# **Addendum**

**Final Environmental Impact Report**  
[State Clearinghouse No. 2019049020]

**Los Angeles International Airport (LAX)  
Airfield and Terminal Modernization Project**

**December 2024**

Figure  
 2

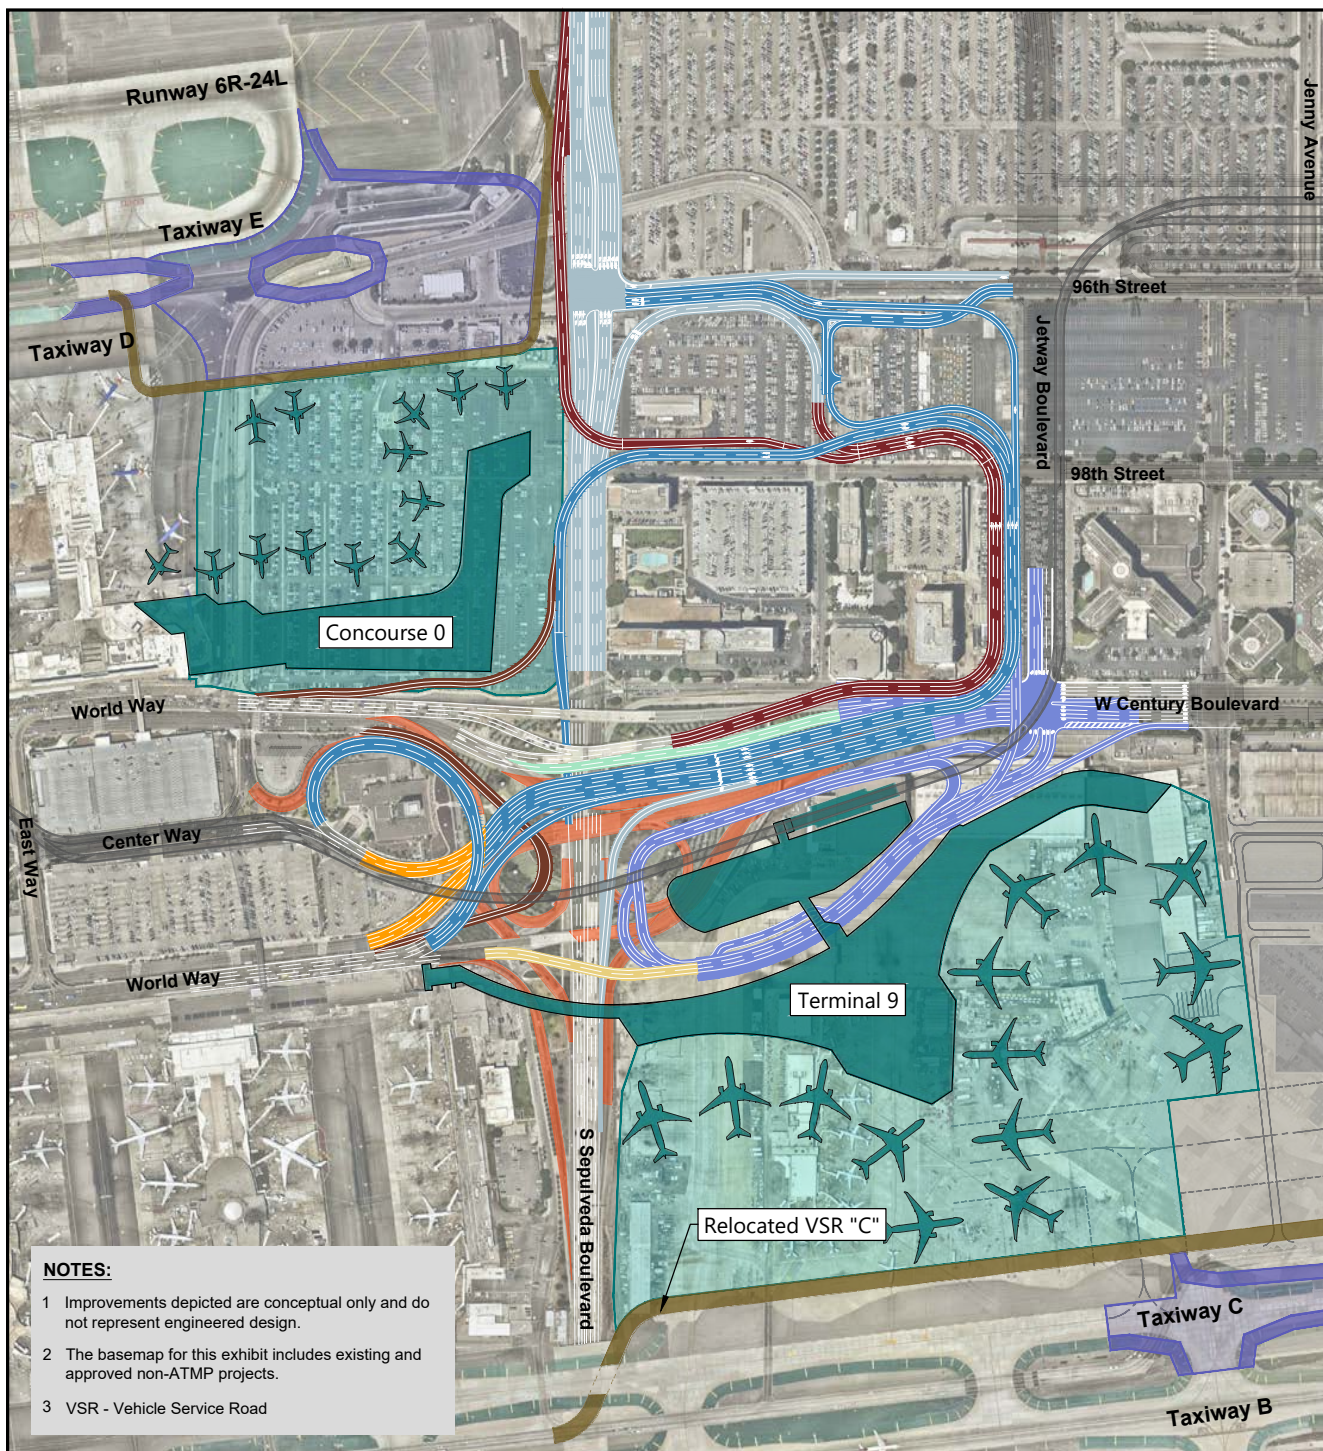
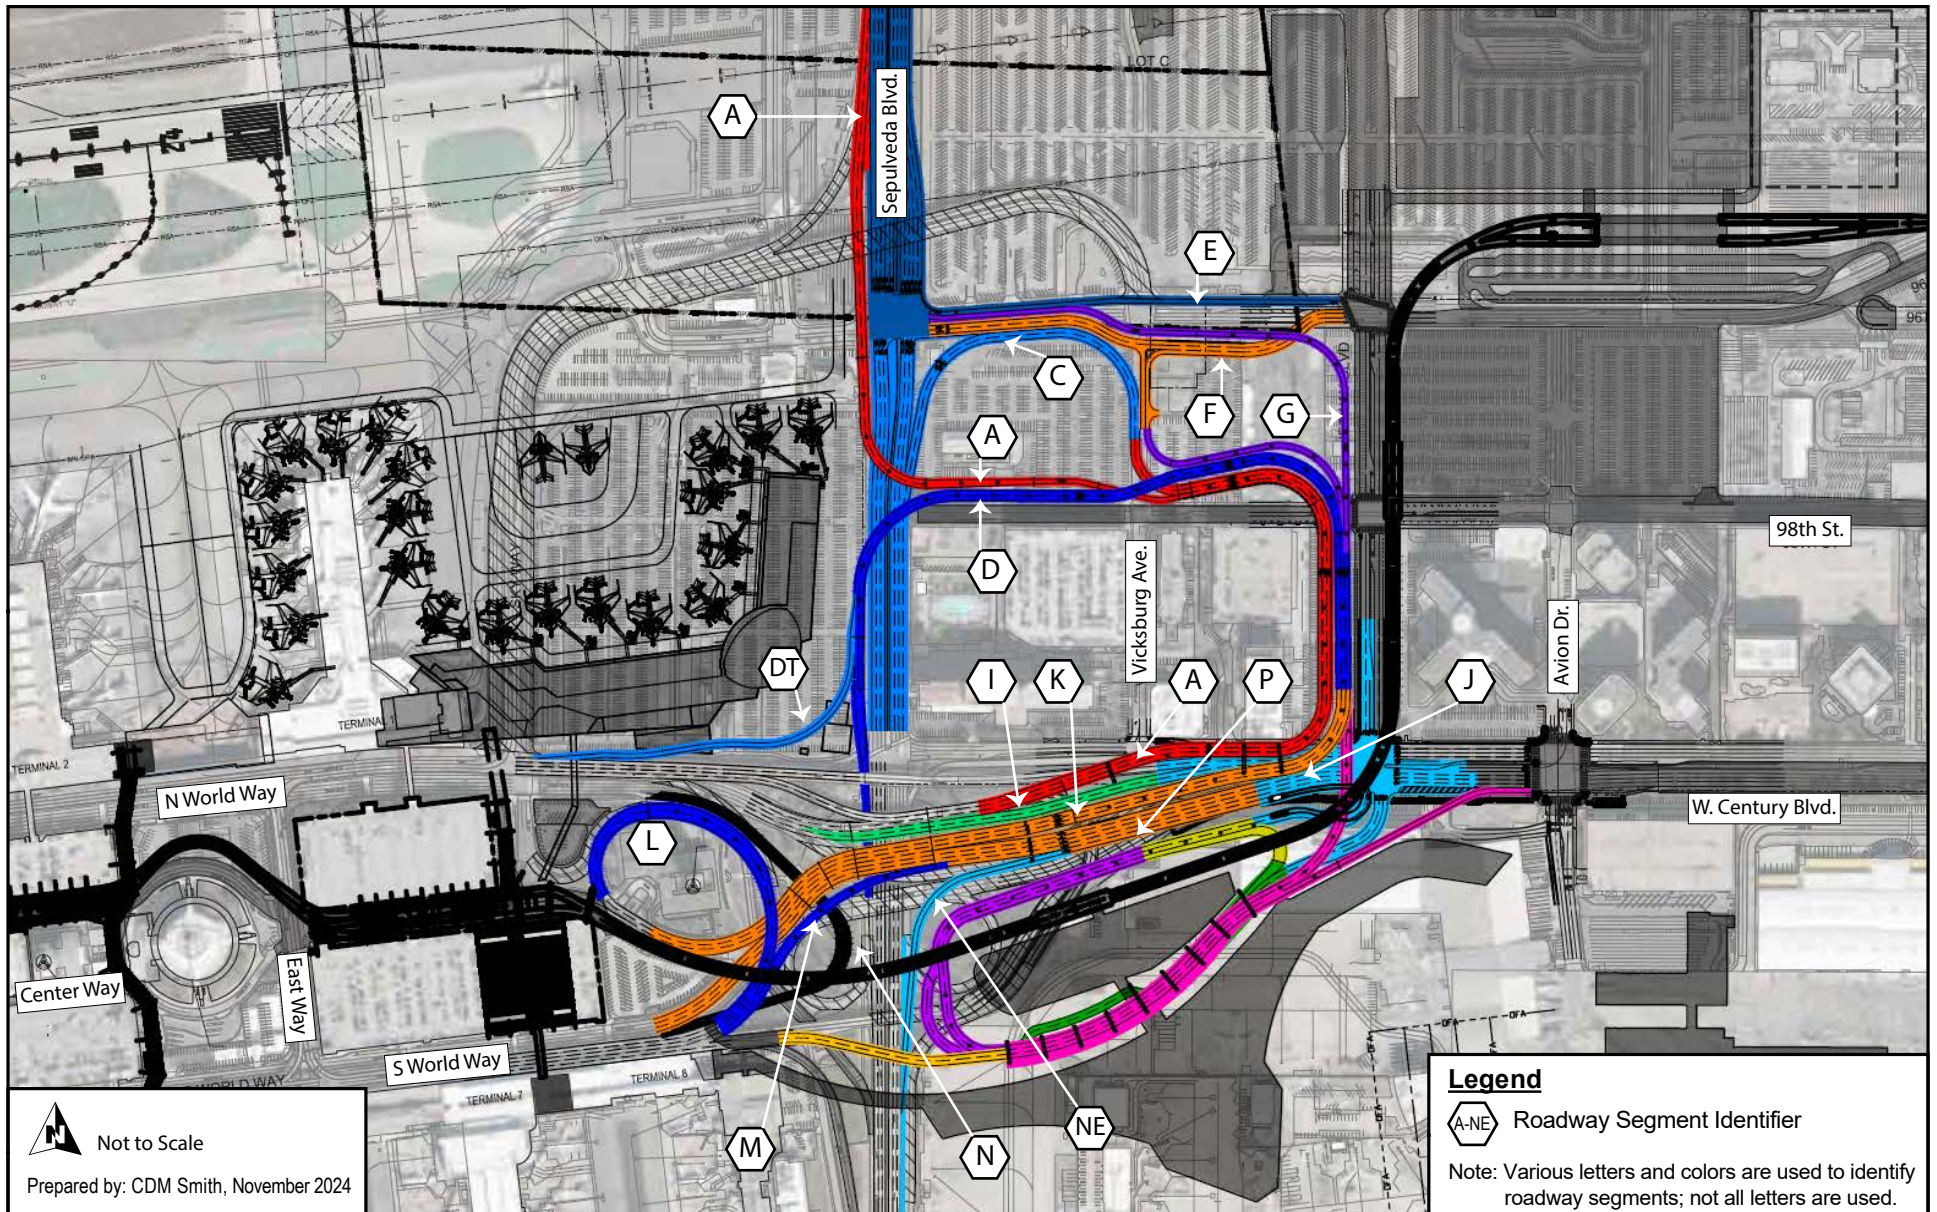
The Approved Roadway System, shown on **Figure 2** and **Figure 3**, was designed to build upon improvements approved as part of the LAX Landside Access Modernization Program (approved in 2017) and provide the following additional benefits for traffic related to the CTA:

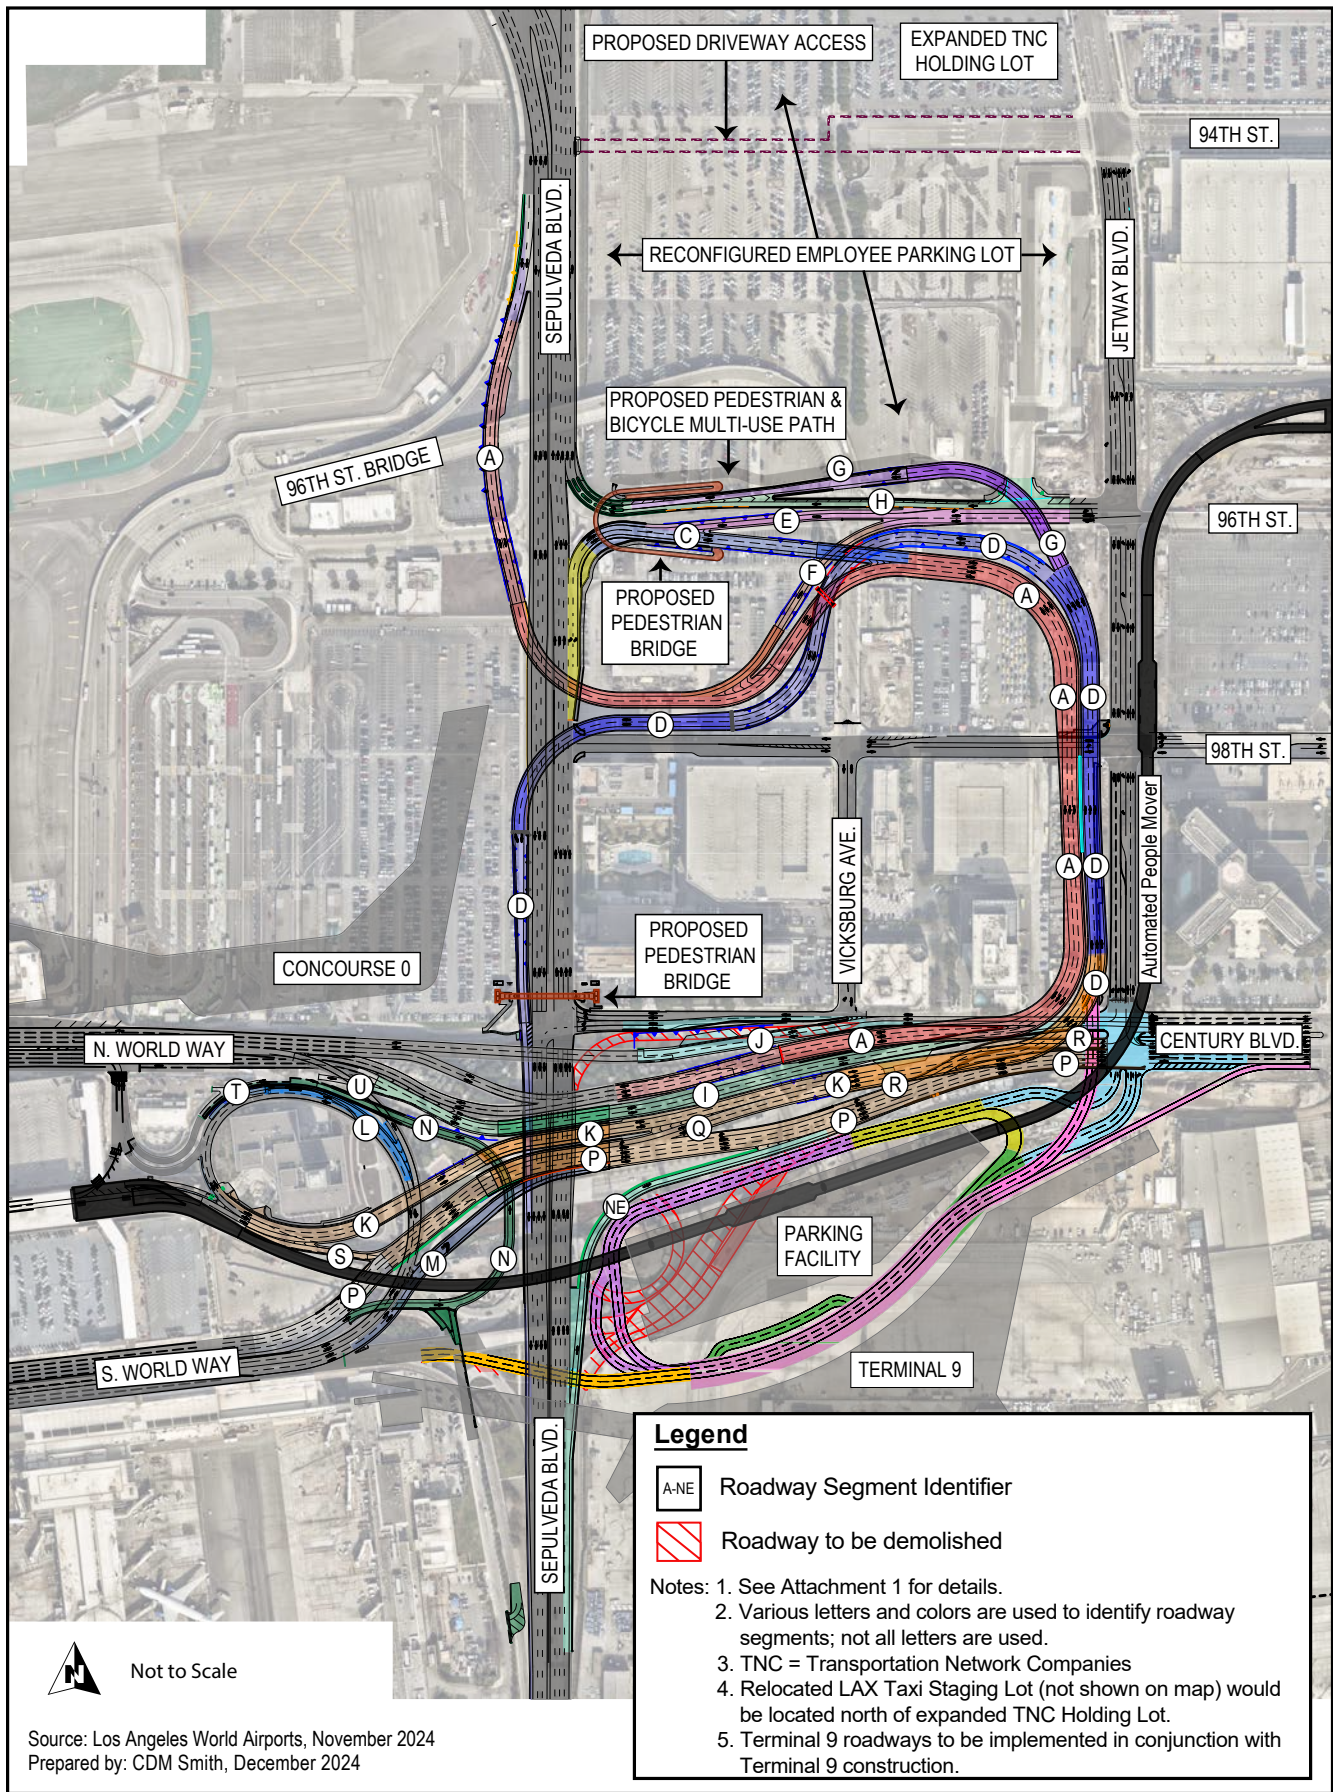
- Realignment of planned road segments and ramps, and modifications to planned new lanes
- Elimination of the originally planned traffic signals at the intersection of Sepulveda Boulevard and 96<sup>th</sup> street to maintain the existing free flow traffic conditions on Sepulveda Boulevard at this intersection
- Two new pedestrian overcrossing bridges, including a pedestrian bridge crossing 96<sup>th</sup> Street east of Sepulveda Boulevard and a pedestrian bridge crossing Sepulveda Boulevard north of Century Boulevard
- Easement and property acquisition refinements

**Figure 4** shows the overall Proposed Roadway System Refinements. **Attachment 1** provides a detailed breakdown of the individual Proposed Roadway System refinement components. The following section of this Addendum describes these key Proposed Roadway System Refinements.

### **Modifications to Roadways North of 98<sup>th</sup> Street**

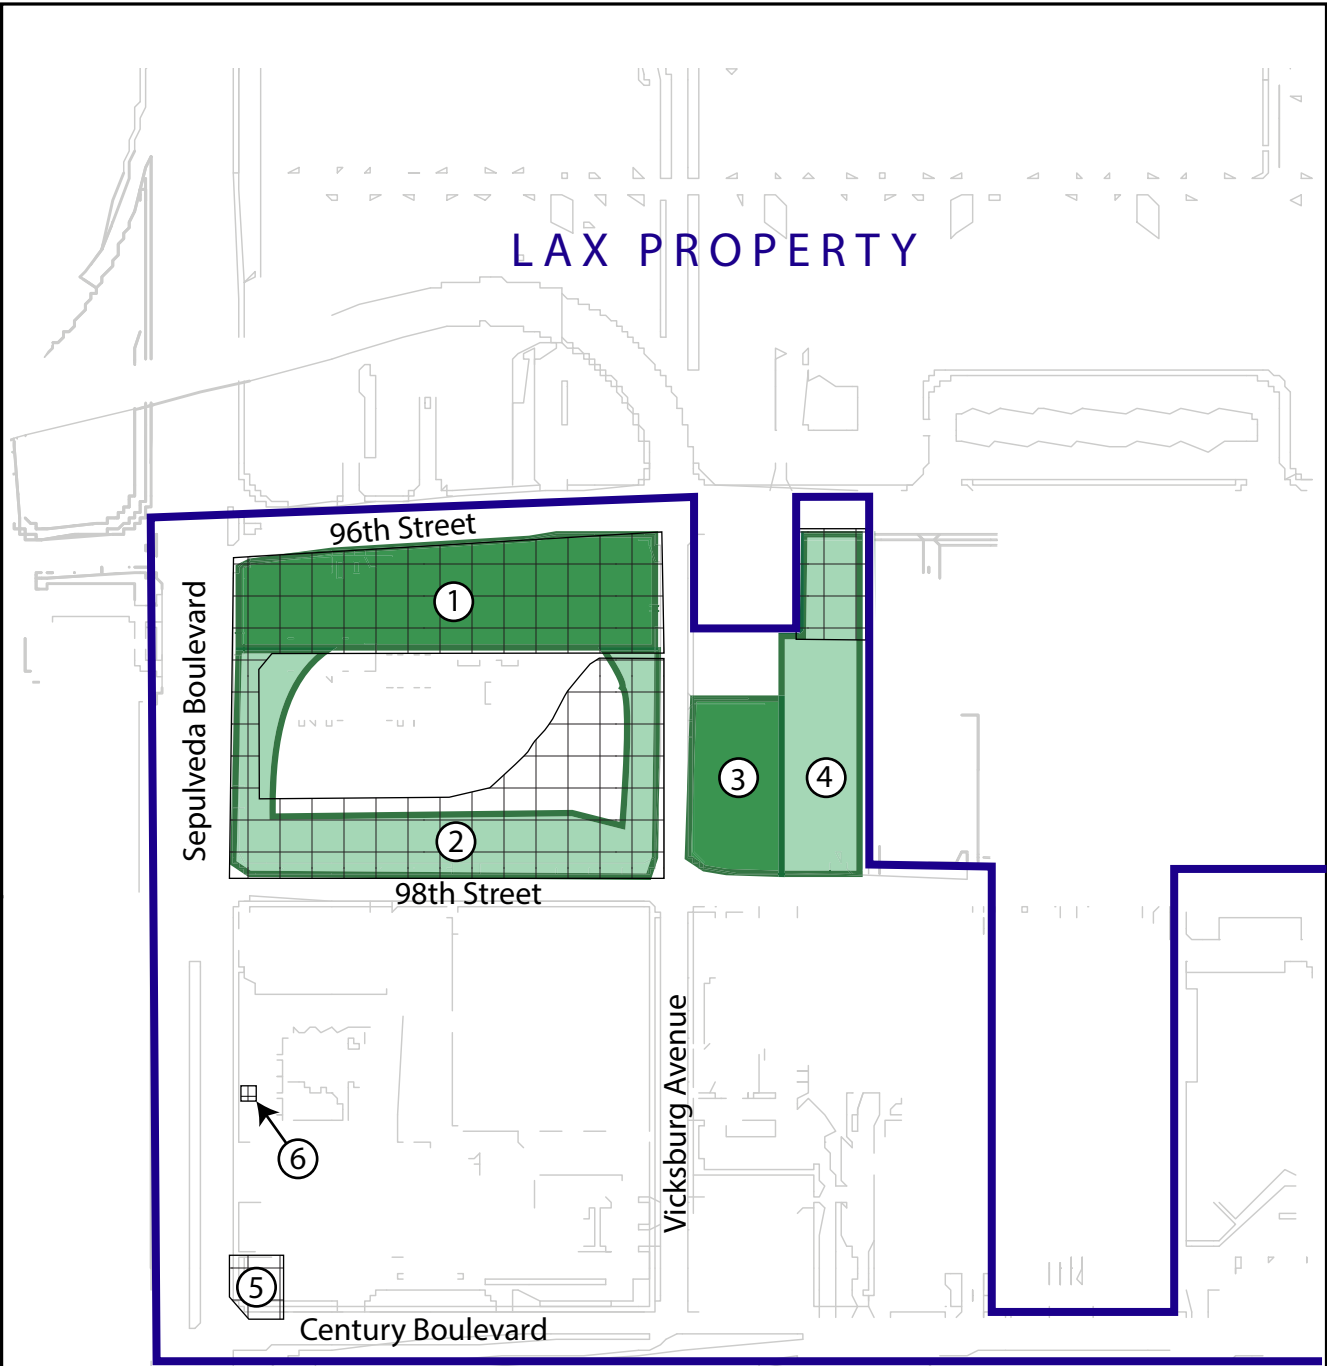
This section describes the key refinements that are generally located north of 98<sup>th</sup> Street and between Sepulveda Boulevard and Jetway Boulevard. Refinements in this area include roadway alignments, easements and property acquisitions, and street closures/modifications.

The realigned Segments A and D (as well as the realignment of Segment F discussed further below) would require additional property acquisition of the LACCD property located on the northeast corner of 98<sup>th</sup> Street and Sepulveda Boulevard (see Attachment 1, Figure 1A, Image 2). Property acquisition requirements under the Approved Roadway System as compared to the Proposed Roadway System Refinements are identified in **Table 1** (in Section 3.4 below) and on **Figure 5**. With the realignment, the Segment A roadway would be closer to the Former Aircraft School Building located on the LACCD property than under the Approved Roadway System (approximately 38 feet to the south as compared to 65 feet, and approximately 90 feet to the east as compared to 327 feet), although the proposed roadway improvements to the west would be farther from the Aircraft School Building (approximately 70 feet west as compared to 45 feet).

In addition to the alignment changes described above, the originally-planned connection from northbound Segment G to eastbound 96<sup>th</sup> Street (via Segment F), which would have also provided access to Jetway Boulevard, would be eliminated (see Attachment 1, Figure 1A, Image 3; eastbound access to 96<sup>th</sup> Street under the Proposed Roadway System Refinements is discussed below). Under the Proposed Roadway System Refinements, outbound access from the CTA to Jetway Boulevard would be provided by Century Boulevard via Segments P and R.
